Item 4.**Development Application: 331-337 Kent St, Sydney - D/2021/35**

File No.: D/2021/35

Summary**Date of Submission:** 2 February 2021

Proposal Summary: Approval is sought for alterations and additions to the existing 10-storey commercial building at 331-337 Kent Street, including significant demolition of existing building elements, structural upgrade works, and refurbishment of the existing four-storey historic warehouse facade. A new four storey addition is proposed resulting in a 15 storey commercial/retail building with a total building height of 61.73m (RL 80.125). Works to the existing ground level carpark are proposed, including new end of trip facilities, bicycle parking, loading and servicing bays, courier parking spaces, and building plant and services. Minor excavation to facilitate a new lift pit is proposed.

Figure 44: Amended top of building signage

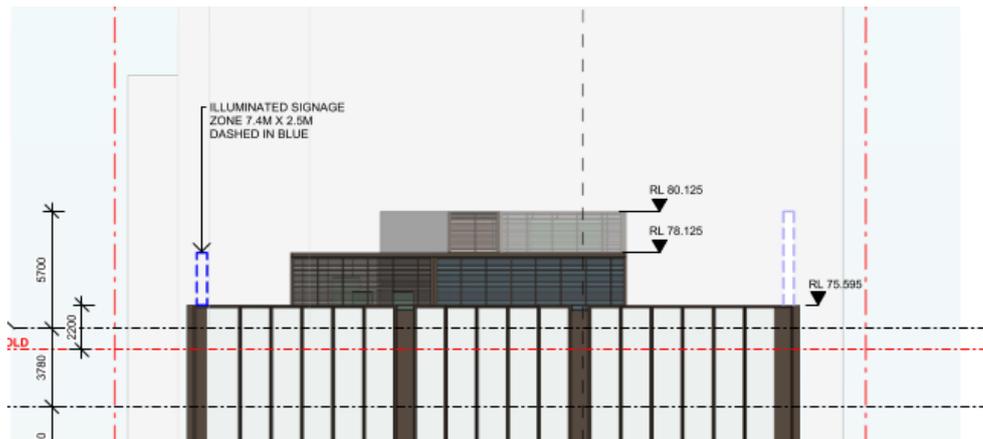
43. Two top of building signs are proposed, their location revised during the assessment, as concerns were raised by the City's Urban Design unit in regards to the original DA's signage location and setting within the architectural facade. An amended location for the signage was provided in the revised drawings dated 27 May 2021 and the signage can be shown in Figure 44 below.

3.16 Signage and Advertising	No	<p>Two signage zones are proposed to the top of building on the eastern (Kent Street) and western (rear) facades. The applicant was advised during the assessment that the top of building signage zone should be amended so that a spandrel or parapet is considered, designed to accommodate a top of building sign consistent with Section 3.16.5.2(8) of the Sydney DCP 2012, which requires top of building signage to achieve a high level of integration into the architectural design of the building.</p> <p>In the amended drawings a revised location for the signage, above the parapet, was proposed. The revised signage is not consistent with Section 3.16.5.2(2) of the Sydney DCP 2012 which requires top of building signs to not project vertically above the roof.</p>

Provision	Compliance	Comment
		The signage is considered to have an adverse impact on the surroundings including the immediate neighbours and is not compatible with the architectural design of the building. As such, a condition to not approve the top of building signage, and require a separate Signage Strategy to be submitted and approved by Council is recommended in Attachment A.
3.1.7 Contamination	Yes, subject to conditions	<p>As discussed above in relation to SEPP 55, the City's Health and Building Unit has reviewed the revised preliminary site investigation report submitted to satisfy both the SEPP and Section 3.17 of the Sydney DCP 2012.</p> <p>The advice received advises that, subject to recommended conditions relating to contamination in Attachment A, the site can be made suitable for the proposed development.</p>

44. The amended top of building signage has been considered against the objectives of the policy and does not comply with the objectives of SEPP 64. In particular, it is considered to have a detrimental impact on the character of the area due to its size and location, protruding above the parapet, and therefore does not have a positive contribution to the streetscape and setting of the area.

Figure 46 - Floor plan of Levels 5-8 - nil setback to north and south

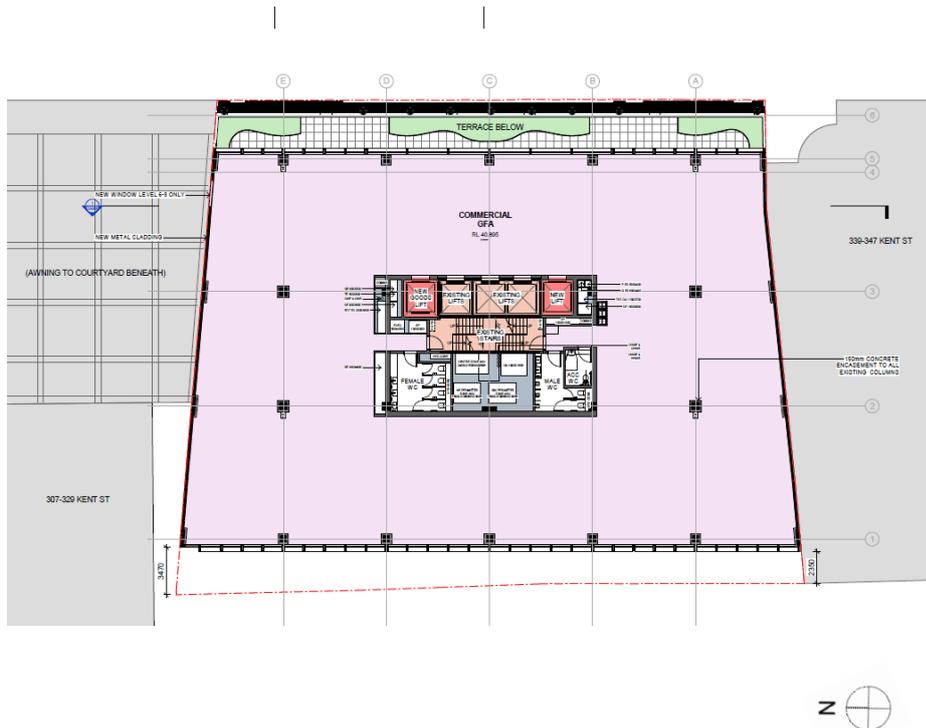
66. Section 5.1.2.2 of the Sydney DCP 2012 requires that, above a height of 45m, windows or balconies of commercial buildings are to be setback at least 3m from side and rear property boundary. The Sydney DCP 2012 also allows solid boundary walls (with no windows) to be built to the boundary. Following a preliminary assessment, the applicant was requested to amend the side and rear setbacks above Level 8 to be at least 3m with no encroachments from facade blades.
67. The amended application proposes the following setbacks:
- (a) Nil setbacks to the side boundaries between Levels 5-8 (consistent with the existing built form) as shown in Figure 46;

68. Up to Level 9, the building is built to the northern side boundary (see Figure 46). As this part of the building comprises a solid boundary wall (with the exception of a new large window between Levels 6 to 8 near the Kent Street frontage), this setback largely complies with the DCP. This arrangement is considered to be acceptable as:
- (a) The window is located above the neighbouring forecourt canopy and does not result in unreasonable amenity impacts;
- (b) The window provides visual interest and relief to what would otherwise be a large boundary wall on the prominent north-east corner of the building as viewed from Kent Street;
- (c) The non-essential window (from a Building Code of Australia perspective) is recommended to be subject to a boundary window covenant condition requiring it to be blocked up if and when the neighbouring site redevelops.

Figure 47 - Encroachment of vertical blades into 3m rear (western) setback area on Level 9

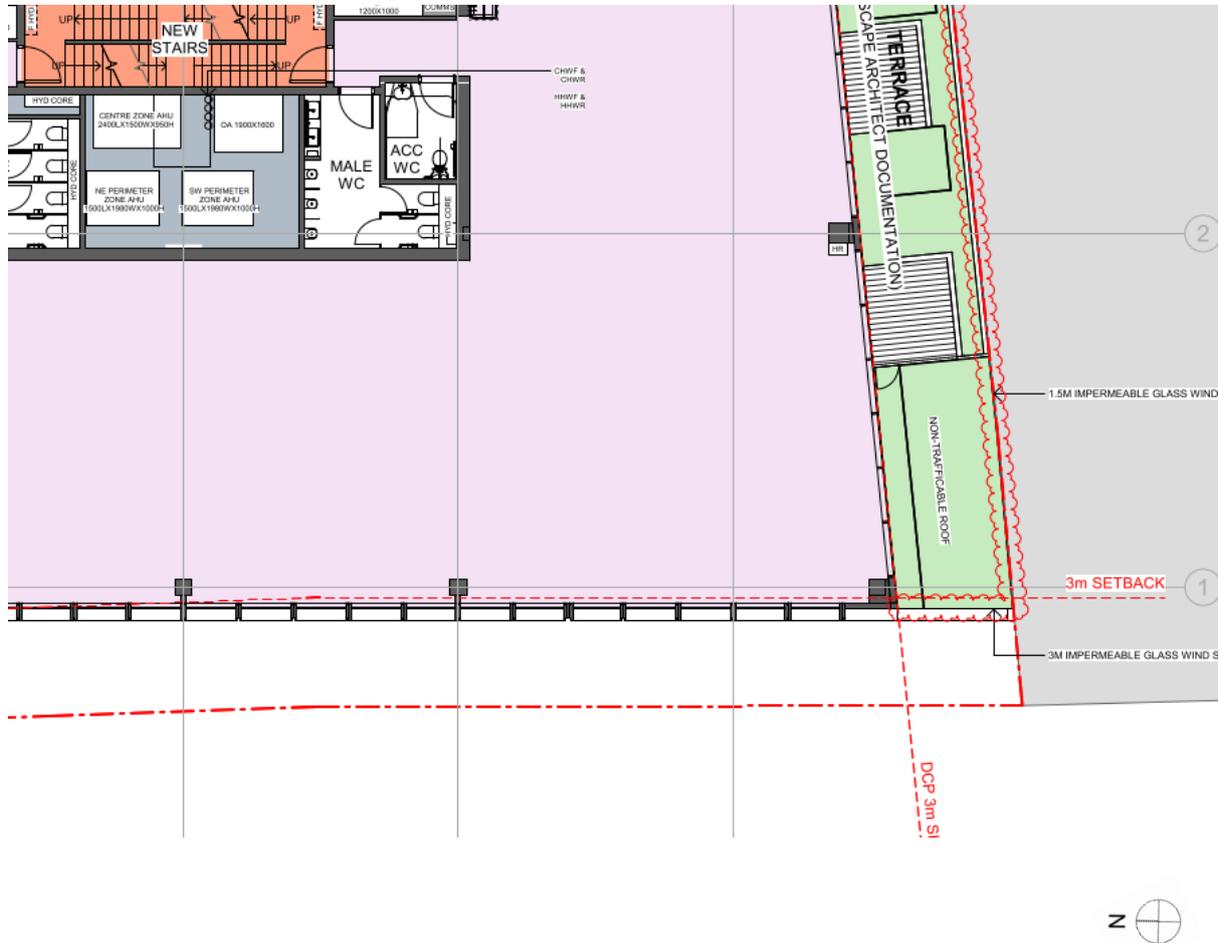
69. The balance of the proposal generally complies with this control however due to the angled boundary lines, there is a minor encroachment from the facade blades at the southern boundary, to the western side of the building. A minor encroachment on the northern boundary into the 3m setback from the vertical blades also occurs, on Levels 10-14 only, so that the actual setback to the boundary is between 2.7m and 2.8m (See Figure 48). As shown in Figure 49 no encroachment to Level 9 northern boundary into the 3m setback is proposed.

Figure 51: Updated photomontages of amended DA facing south (left) and north (right)

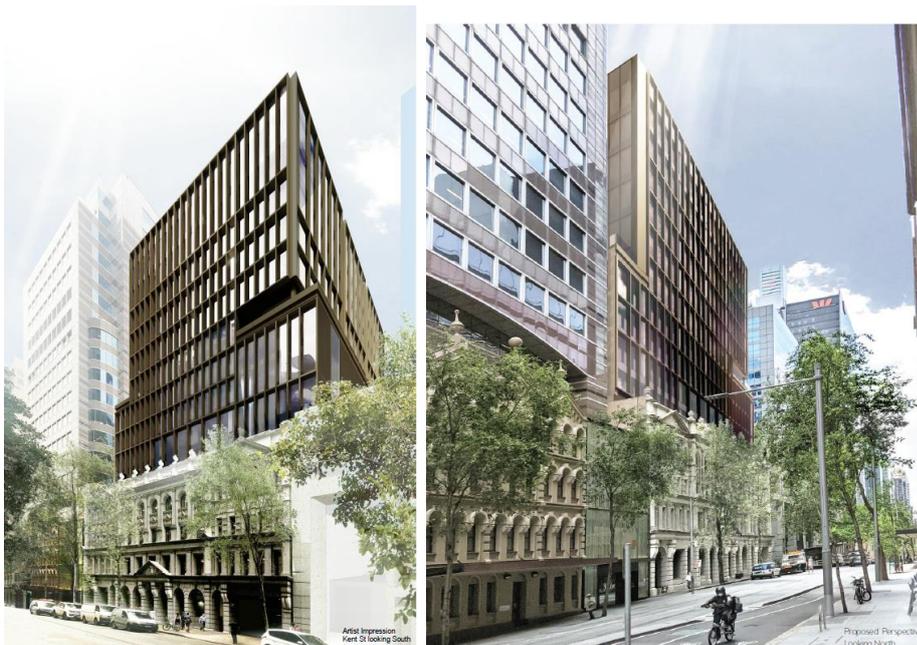
85. Following a preliminary assessment, the applicant was requested to amend the architectural design of the facade to address comments from DAP and the City's Urban Design and Heritage Specialists in regards to the relationship of the new facade with the lower levels of the historic former warehouse facade.
86. The originally submitted facade design was considered to compete too heavily with the historic existing facade proposed for retention. In addition, the encroachment of the facade blades within the 3m setback area was considered to reduce the perceived relationship to the site boundaries.
87. As shown in Figures 50 and 51, the facade design has been amended to include facade blades at 300mm depth placed at 1.5m centres along the northern, eastern and western elevations, and fritted glazing along the northern-most portion of the western elevation.

Figure 52: Proposed section plan and location of shadow line, recommended to be shifted upwards to Level 6.

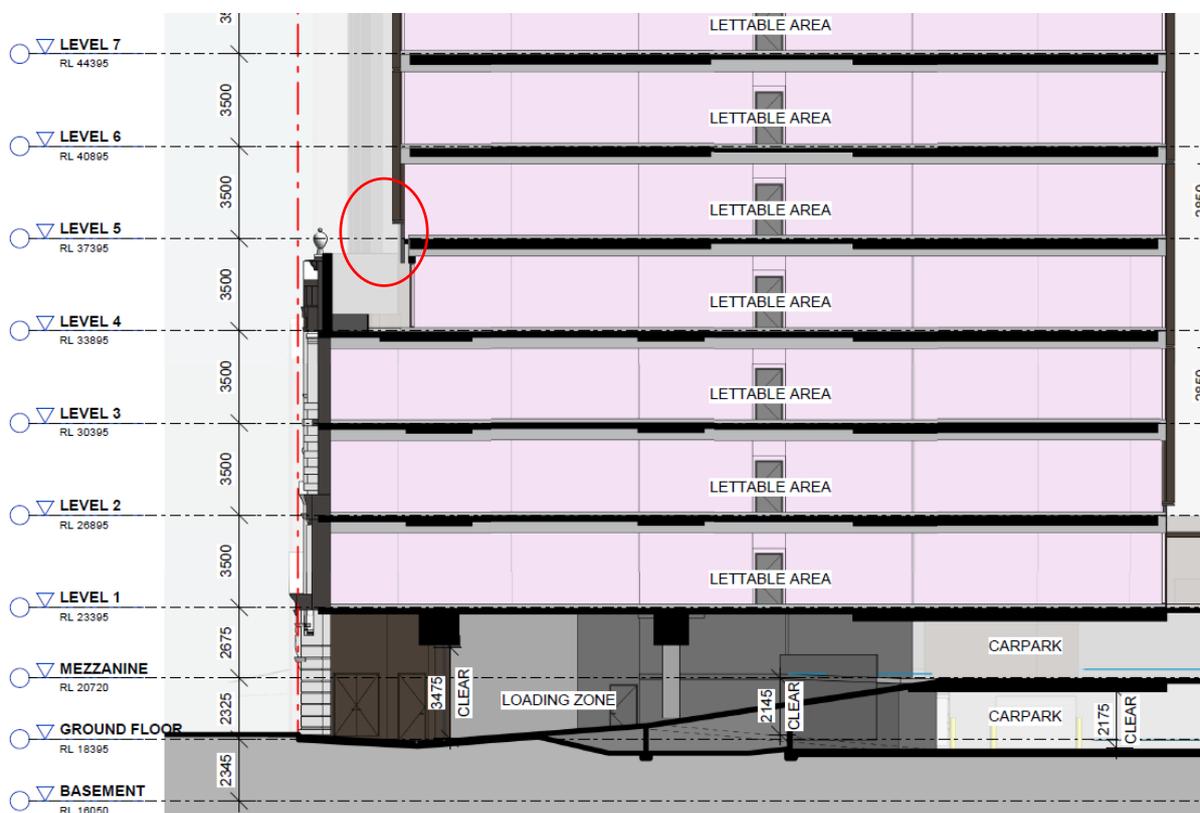
88. To separate between old and new elements, the revised plans include a horizontal shadow line at the existing facade parapet constructed in bronze materiality to distinguish the new vertical addition.

89. The City's Heritage and Urban Design Specialists recommended that the height of the shadow line be moved from Level 5 to Level 6 as it was noted that the shadow line appears to be difficult to discern from Kent Street, as the shadow line RL is too close to the RL of the parapet - the visual benefit and relationship with the parapet is only achieved when the shadow line is presented on top of the heritage parapet, so that it is visible from the street.

90. To address this, a recommended condition of consent in Attachment A is included to require the shadow line RL to be moved from Level 5 to Level 6. Subsequently the glazing line at Level 5 will be required to be realigned to match Level 4.

Figure 53: Details in the Design Report. An opaque spandrel is required to conceal the slab and the ceiling cavity.

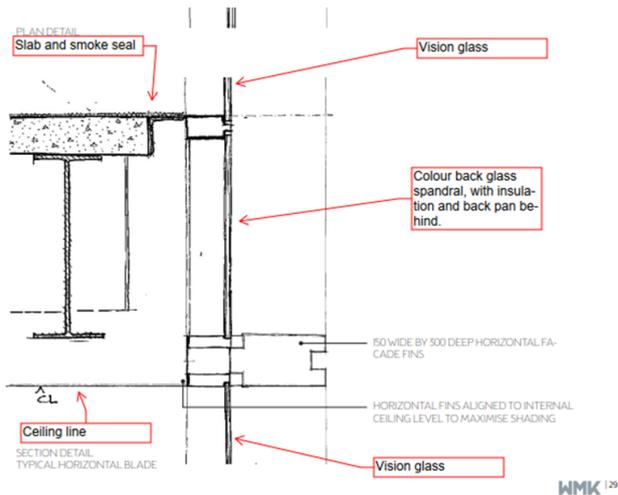
91. The City's Urban Design officer noted that an opaque spandrel to conceal the slab and the ceiling cavity was required. Details at a scale 1:10 have been provided in the Amended Design Report but do not form part of the DA Plans. As such, a condition of consent is recommended for these plans to be provided and approved by Council's Director City Planning Development and Transport prior to Construction Certificate.

Figure 58: Amended mezzanine floor plan omitting the plate steel lining to Kent Street

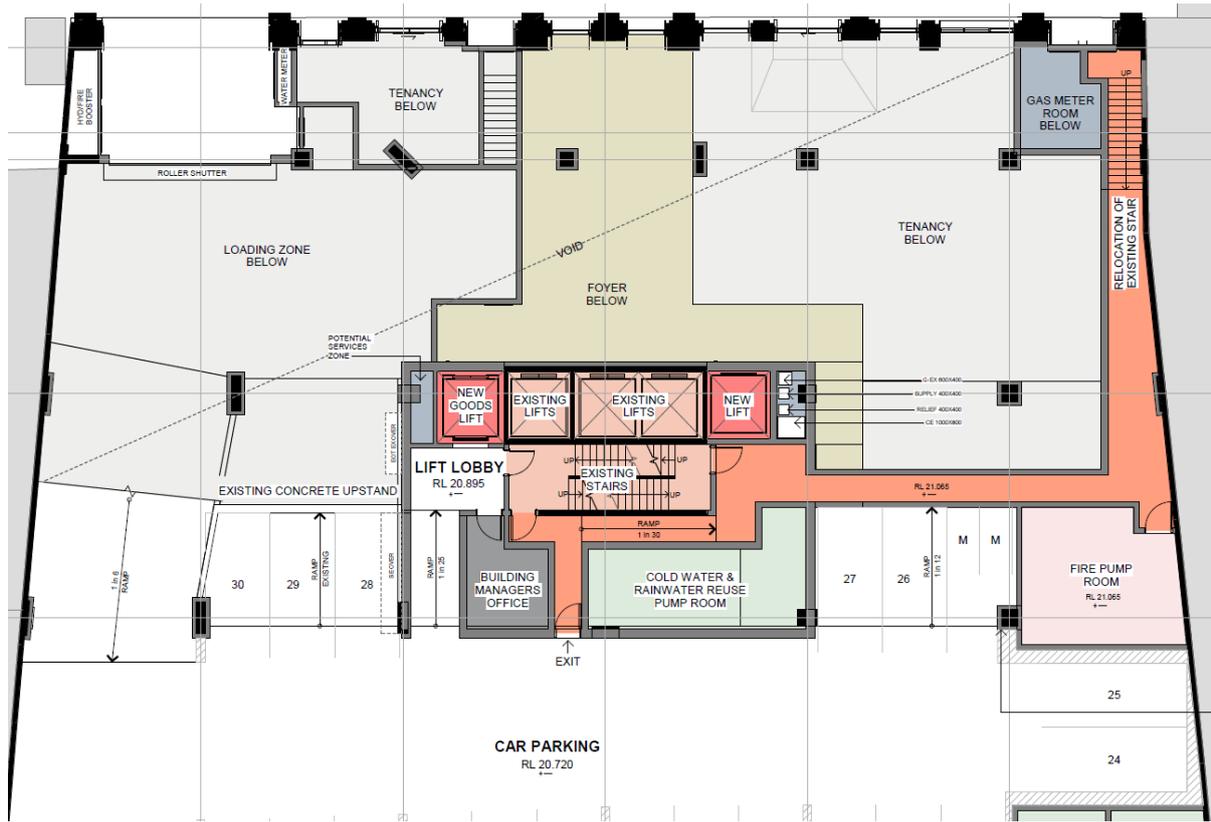
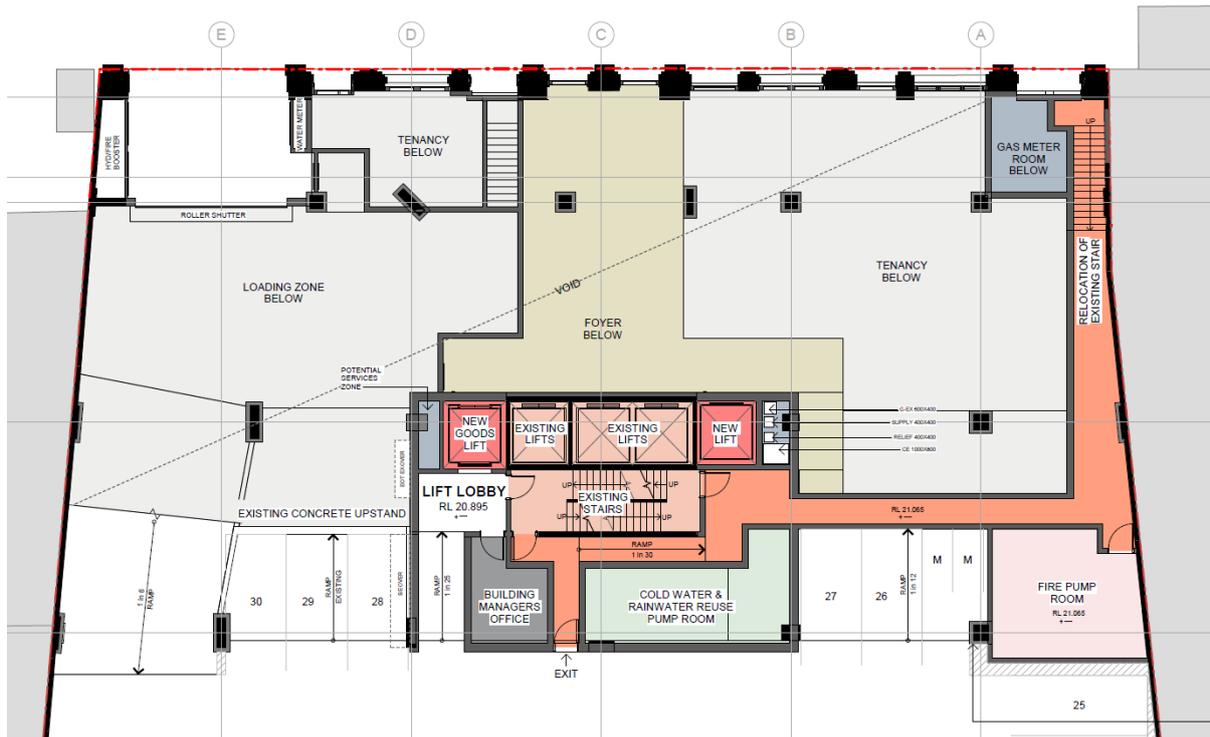
- (b) Impact of proposed plate steel framing to ground floor shown in Figure 56 which would obscure the ashlar joints featured at the corner of the arches; and

99. The applicant has addressed items a) through c) in the amended plans which include reconstruction of the ground level facade window joinery and masonry sills where possible, though it is noted the intervention of fire egress and service access restricts full restoration of each of the original facade bays. A singular off-white finish across the entire elevation is proposed as shown in Figure 57.

100. Officers have reviewed the proposed amendments to the historic facade treatment, noting that the reconstruction of the ground level joinery and upper level window joinery have been largely addressed, so the reconstructed facade better reflects the historic photographs from 1917.

Figure 60: Amended rooftop plant screening and example of vertical louvres proposed

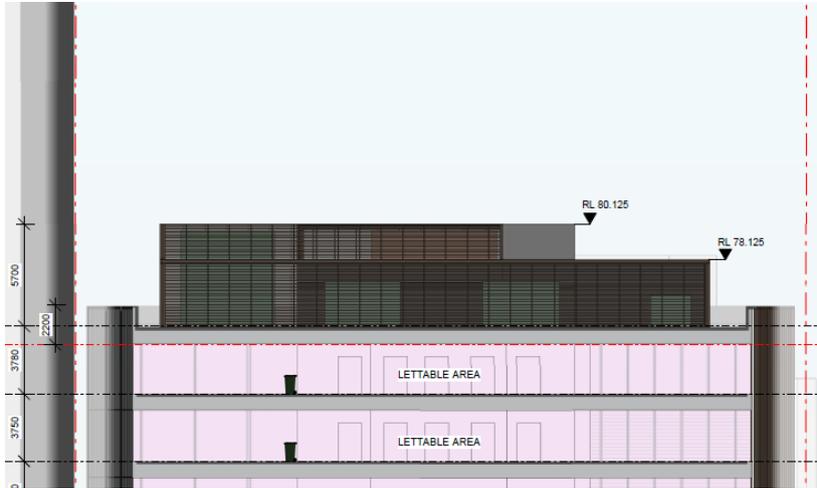
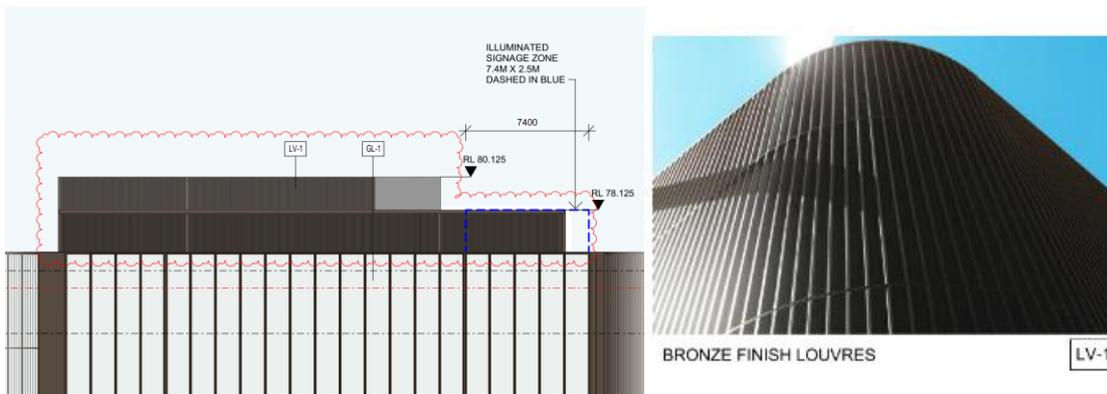
102. The applicant was advised to amend the proposed rooftop screening to be more commensurate with the architecture of the building, as the rooftop level plant would be visible from various vantage points including neighbouring buildings both commercial and residential.

- 103. The proposal has been amended to change the proposed bronze metal cladding (MT-1) to bronze finish louvres. A parapet height of 1.1m is proposed to the top of building as shown in Figure 59.
- 104. The proposed screening is supported in principle, however it is considered that the parapet height should be increased to 1.4m to further improve the appearance of the servicing and plant when viewed from the street.
- 105. As the final design of the servicing and equipment to the rooftop area is subject to further detailed design once DA consent has been issued, conditions to require details of the screening and an increased height of 0.3m to the parapet are recommended in Attachment A.

Figure 63: Overshadowing diagram - 21 June 9.00am-9.15am - additional overshadowing to top balcony in red

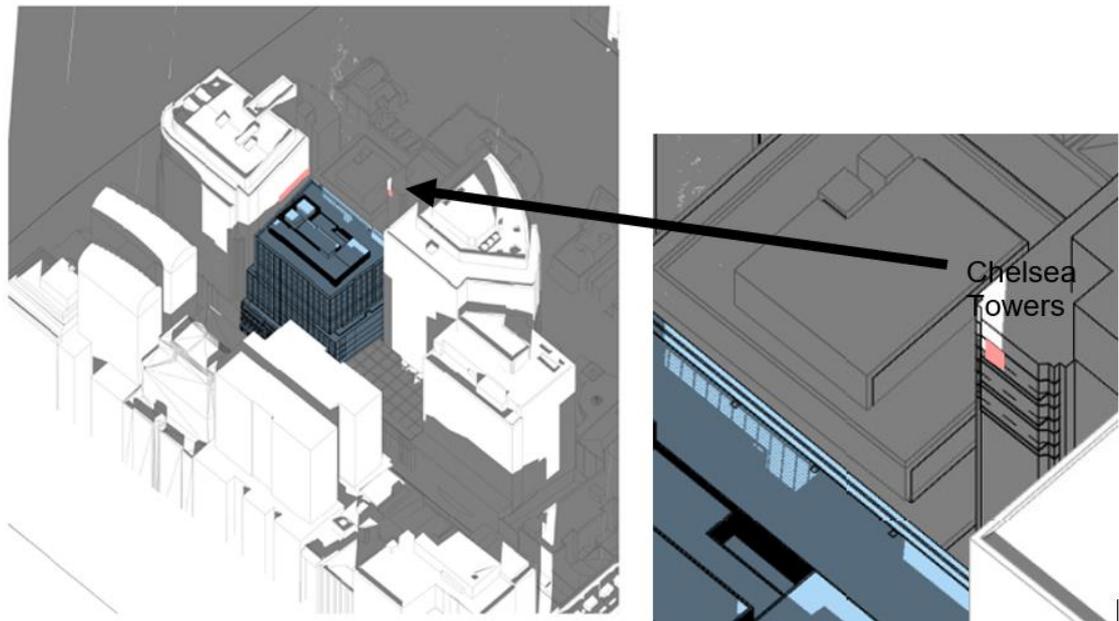
111. Regarding additional overshadowing of surrounding properties, the impact of the proposed envelope is minimal, largely due to the existing form of the building, the broader surrounding CBD context, and the presence of larger scale buildings including at 309-329 Kent Street.
112. There are minimal overshadowing impacts to residential properties nearby, including to 110-116 Sussex Street Sydney. Minor overshadowing is shown to occur between 9am - 9.15am on 21 June as shown in Figure 63 below.

113. The applicant was asked to clarify the overshadowing impacts to this property, and more detailed overshadowing diagrams were submitted, showing the solar access impacts in green below, between 9am and 9.15am, to the balustrade of the balcony of the top unit.
114. The diagrams show that the subject proposal may affect the solar access to the private balconies and bedroom windows of the two top southern apartments between 9am and 9.15am on June 21. These openings are largely in shadow for the rest of the day between 10am and 3pm on June 21 and the proposal reduces the sunlight received so that the resultant solar access between 9am and 9.15am is nil.
